May 10, 1999

To: T10 Technical Committee
 From: John Lohmeyer, LSI Logic Principal Member of T10
 Subj: Proposal to change MSE High-Z Current Specification in SPI-3

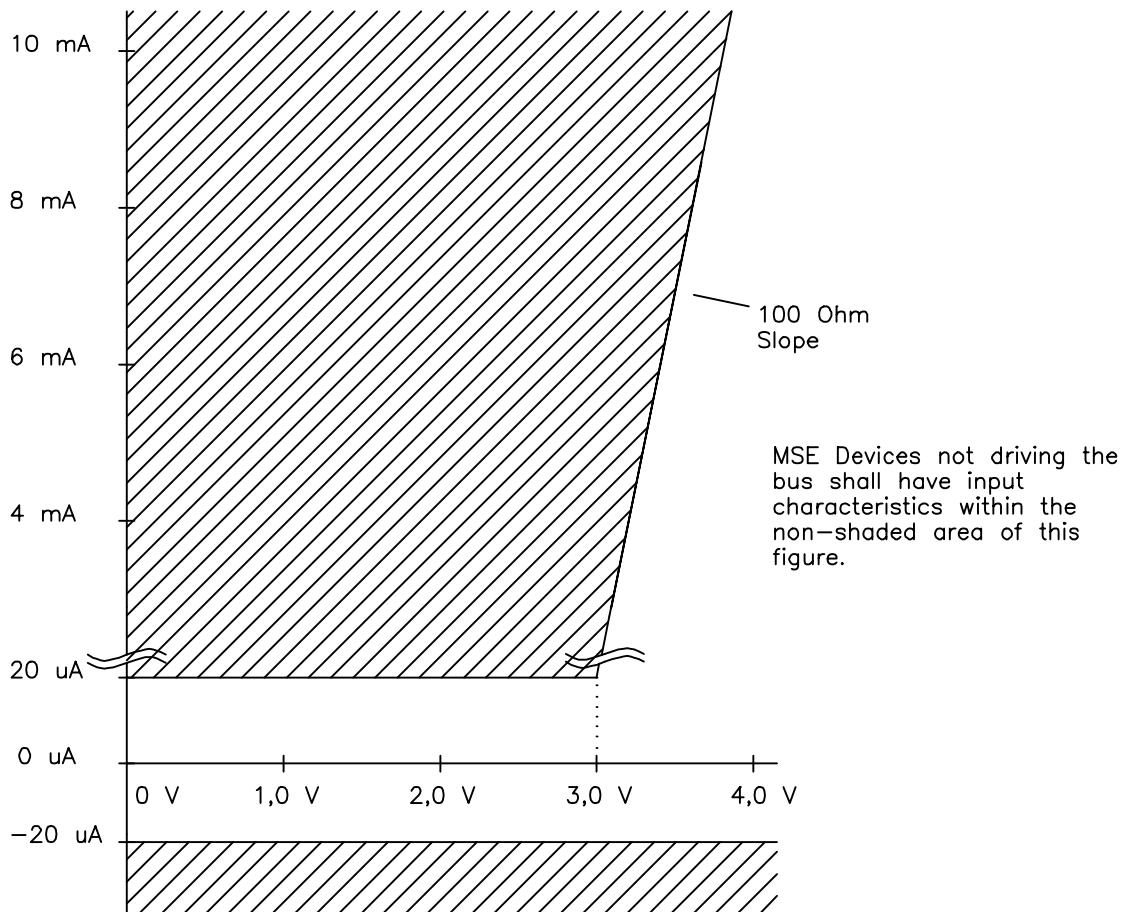
The May '99 SPI-3 working group requested that I develop a written proposal regarding relaxing the High Z input characteristics of MSE devices (i.e., their input characteristics when they are not driving the bus). I propose that the below figure replace the first line of Table 16 (SPI-3, rev 5) as the definition of MSE input characteristics when not driving the SCSI bus.

Annex A, Table A.1: Change the device leakage line as follows: Minimum: -20 (no change); Maximum: see figure <new>; Cross-reference: figure <new>.

Re-word the first paragraph in A.4.1 as follows:

"The requirements in this clause apply as a test method to ensure compliance with table 15, table 16, and figure <new>. With the transceiver in an off condition (i.e., not transmitting) and the + and - signals connected to a variable voltage source, $V_{applied}$, the output high-Z currents I_{i-L} and I_{i+L} shall not exceed the applicable values in table 16 and figure <new> over the range $0,00 V \leq V_{applied} \leq 3,6 V$ (see figure A.11)."
